LIMERICK GENERATING STATION
PROBABILISTIC RISK ASSESSMENT

REVISION 5 PAGE CHANGES

PROBABILISTIC RISK ASSESSMENT
LIMERICK GENERATING STATION
PHILADELPHIA ELECTRIC COMPANY

This revision consists of responses to the NRC request for additional information and updates the PRA to September of 1982. All items contained in this section are grouped according to the Chapters and Appendices of the PRA. Revision of existing pages was due to either, the clarification of responses to previously submitted questions or the correction of typographical errors. Responses to the NRC request for additional information dated August 10, 1982 are inserted at the end of each section. The page numbering has not been redone; rather a suffix has been added to the page number for all inserted material.

Figure 3.4.7 Event Tree Diagram of Accident Sequences Following a Turbine Trip Initiator.

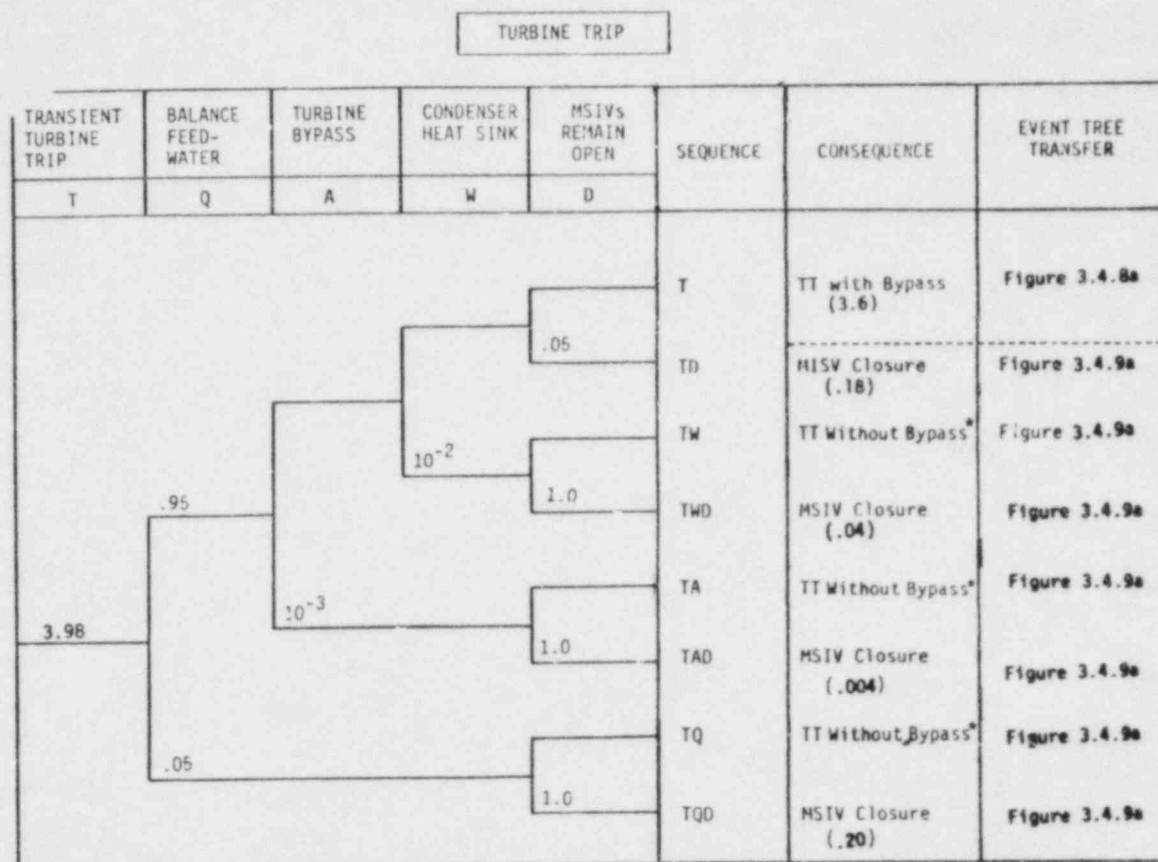
(a) The question relates to the lack of a probability value for secondary containment failure on page 3-66 (Figure 3.4.7). This figure is modified in revision 5 to the PRA to clarify the meaning. The presence of the function, "Secondary Containment", on the event tree was superfluous. It was originally intended to distinguish between cases with relatively small leakage even though the rapid pressurization of the containment during an ATWS condition without mitigation generally precludes obtaining significant benefit from the secondary containment. However, in the most likely scenario in which the intent of Alternate 3A is accomplished, the following will occur:

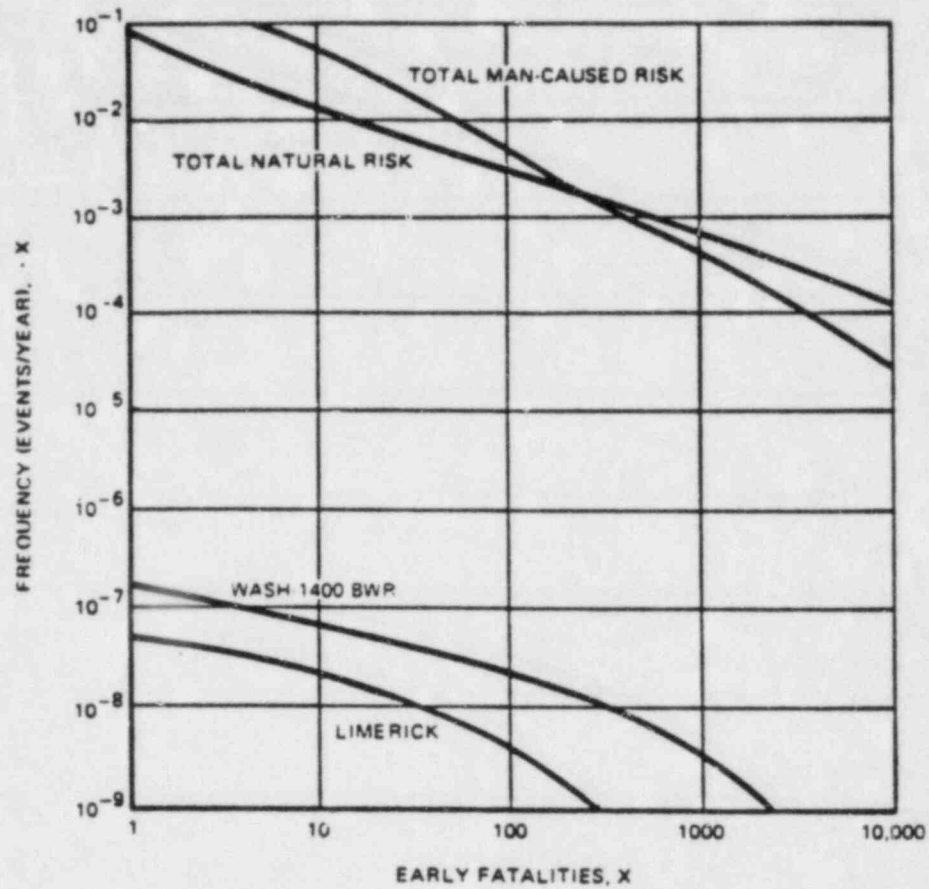
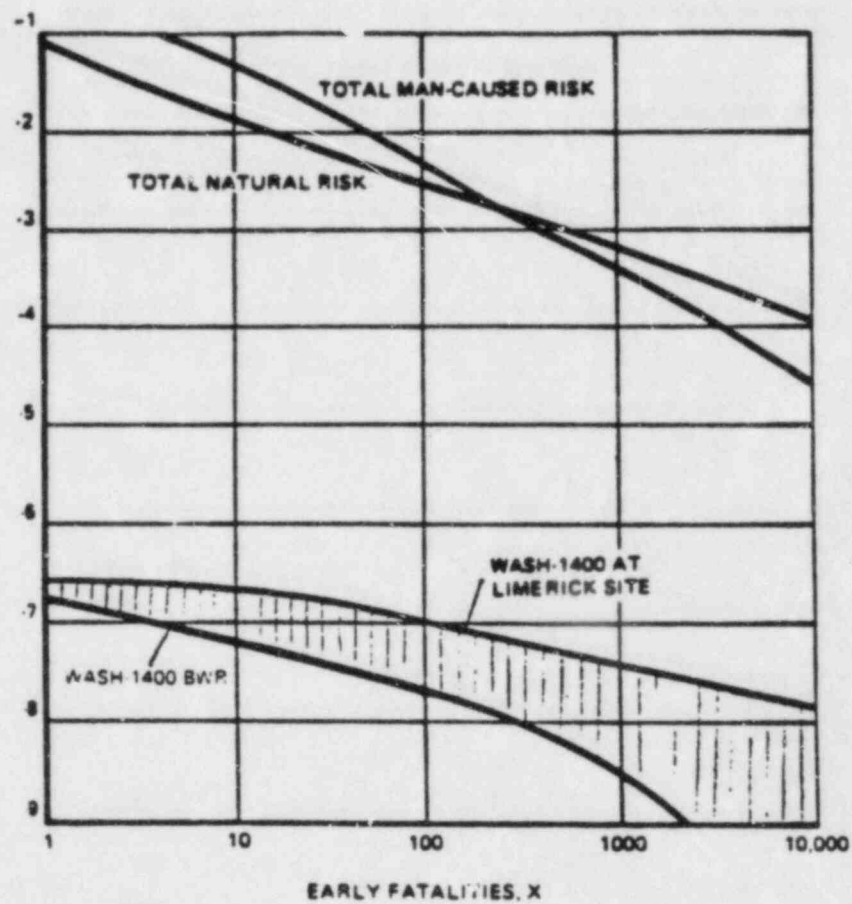
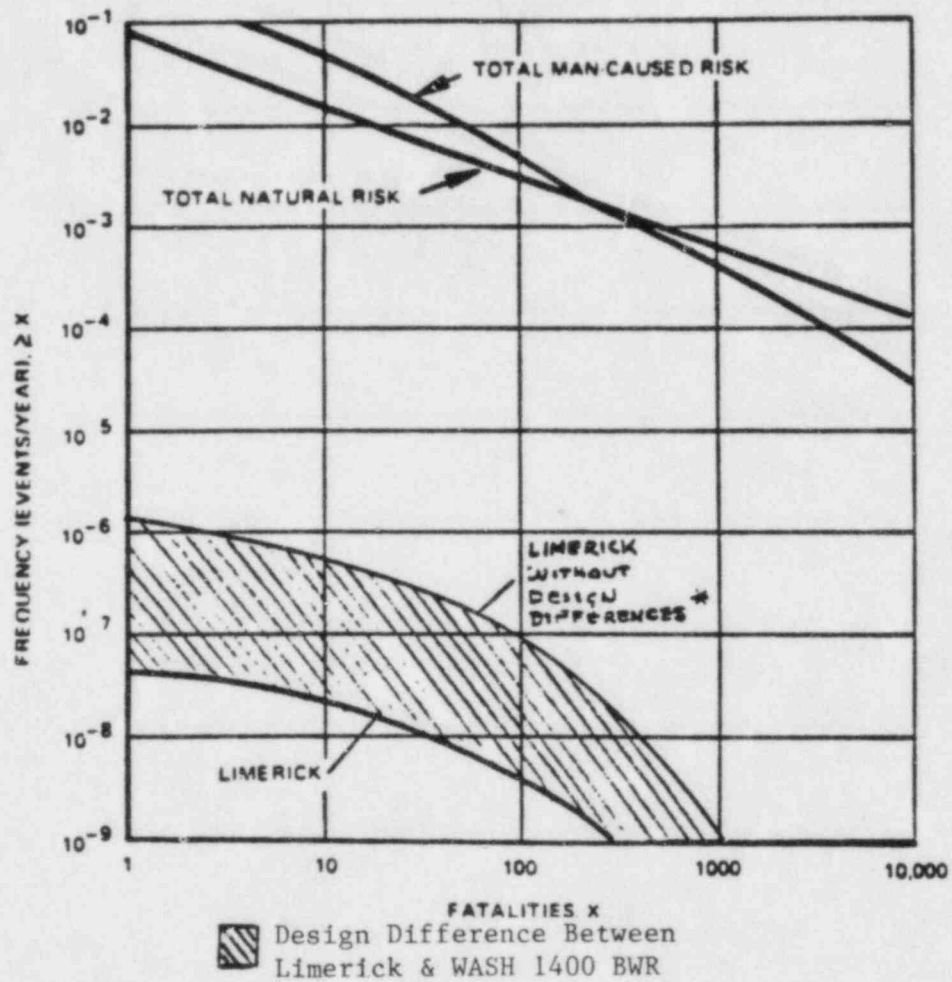
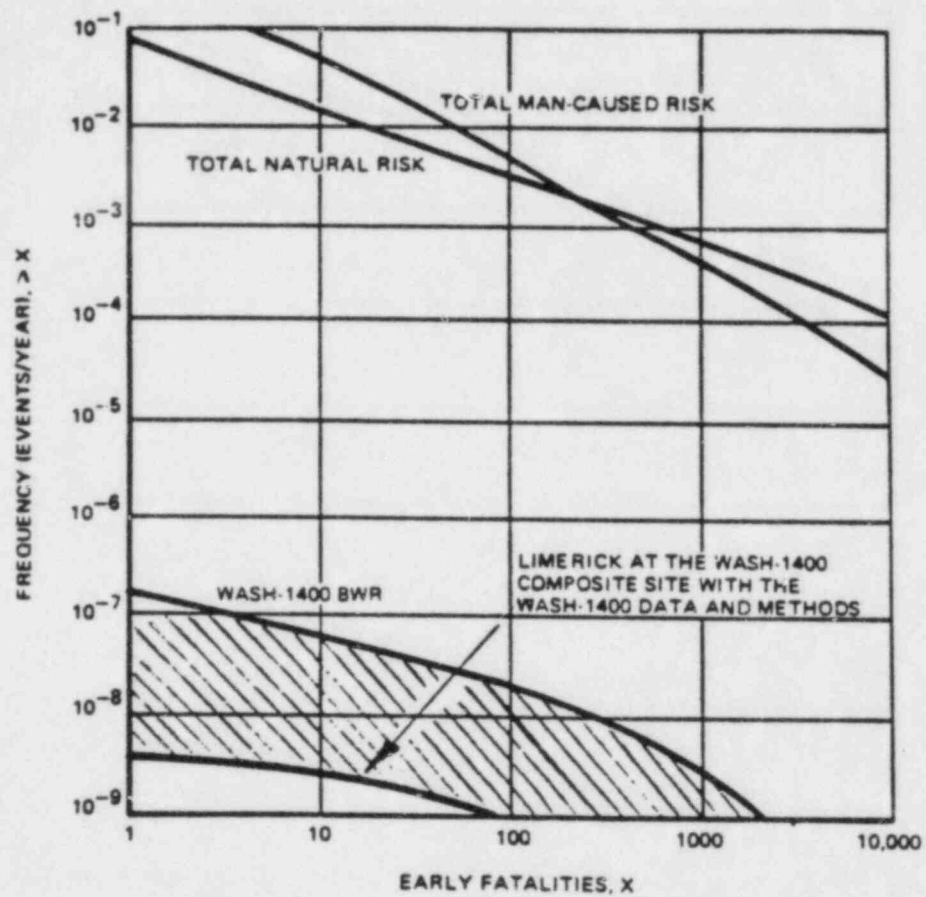
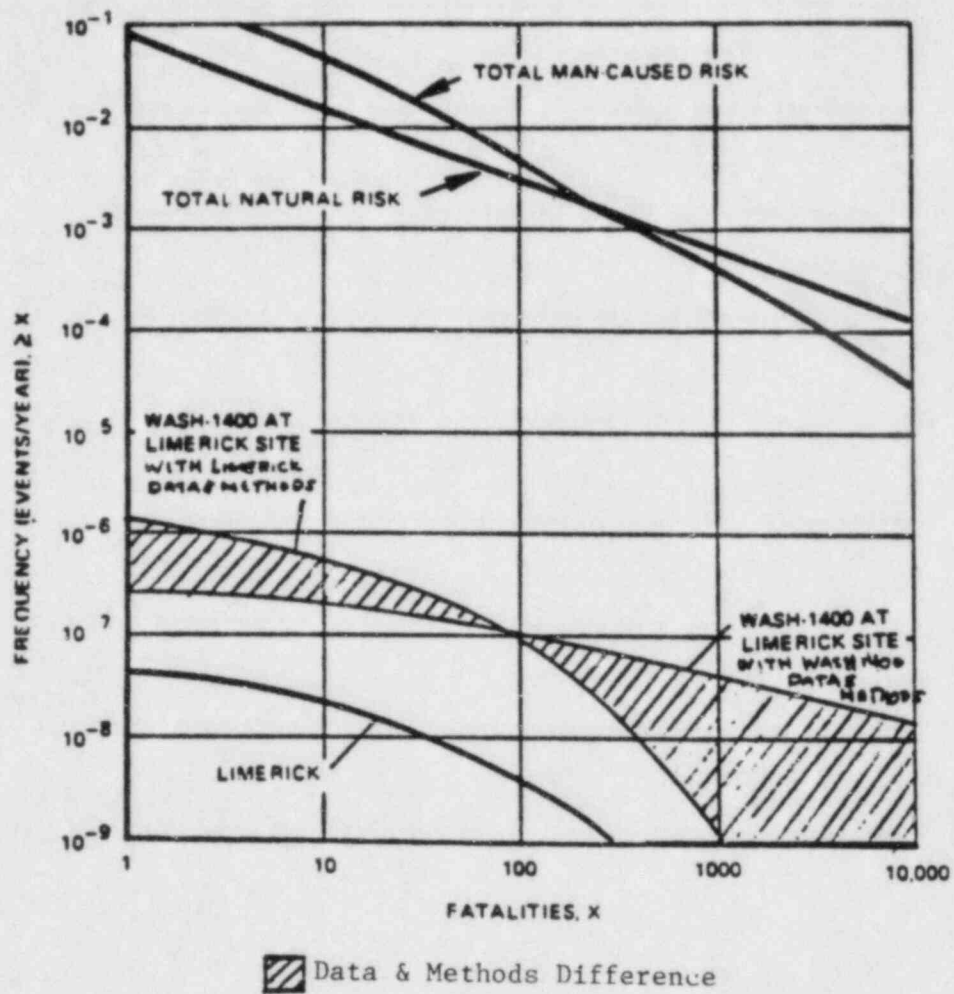
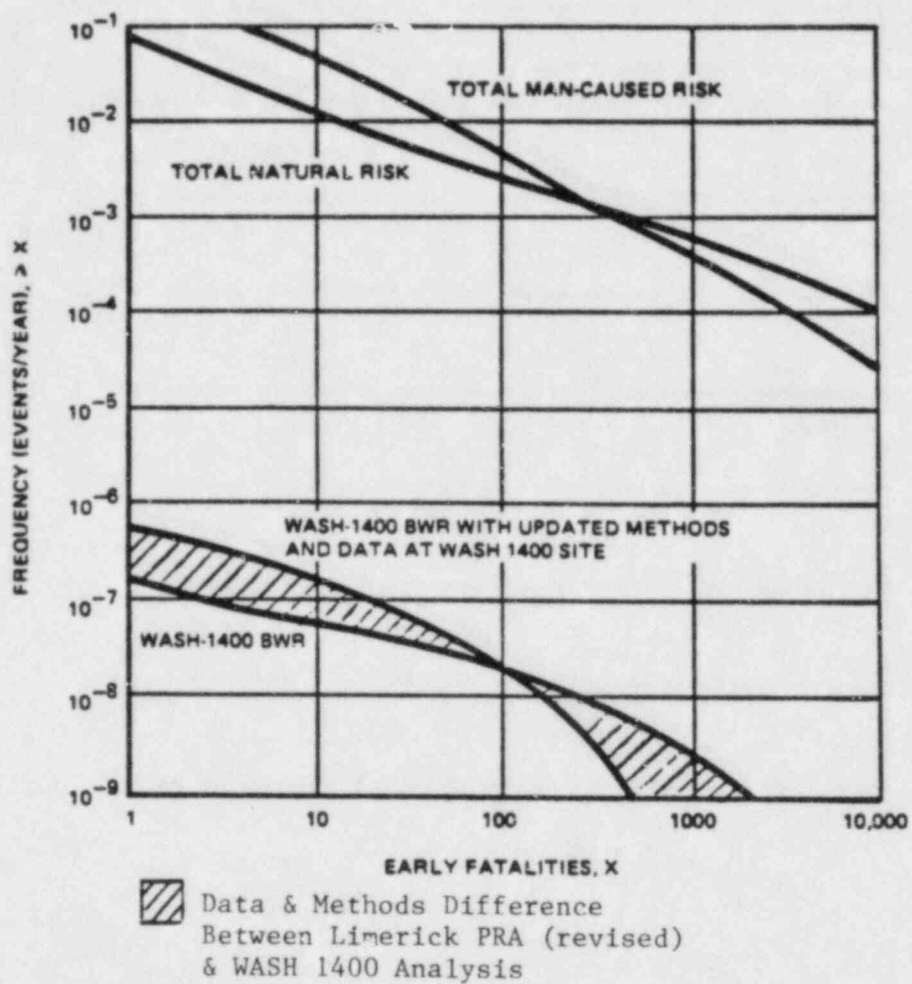
Explain in detail how Figure 4.3 was generated. What exactly was used to compute the risk of Limerick at WASH-1400 composite site with WASH-1400 data methods?

How was Figure 4.2 "WASH-1400 BWR with updated methods and data" obtained?

STEP 1: Figure 1 (attached) was constructed. This is Figure 4.4 in Revision 3 to the PRA.

STEP 2: Figure 2 (attached) was constructed. This is Figure 4.1 in Revision 3 of the PRA.

STEP 3: Figure 3 (attached) was constructed. This figure is not included in the Limerick PRA report.

STEP 4: Figure 4 (attached) was constructed. This is Figure 4.3 in Revision 3 to the PRA.

The lower curve was not generated directly from a CRAC run. It was generated by applying the difference between the two curves on Figure 3 to the WASH-1400 CCDF, by ratio. Points on the lower curve of Figure 4 have the same ratio to the upper curve as the ratio between the lower and upper curves on Figure 3.

STEP 5: Figure 5 (attached) was constructed. This figure is not included in the PRA report.

STEP 6: Figure 6 (attached) was constructed. This is Figure 4.2 in Revision 3 to the PRA.

The curve that is uppermost on the left represents the WASH-1400 BWR at the WASH-1400 site with the data and methods used in the Limerick analysis. This curve was not generated directly from a CRAC run. It was generated by applying the difference between the two curves of Figure 5 to the WASH-1400 CCDF, by ratio. Points on this curve have the same ratio to the WASH-1400 CCDF as the ratio between the two curves on Figure 5.
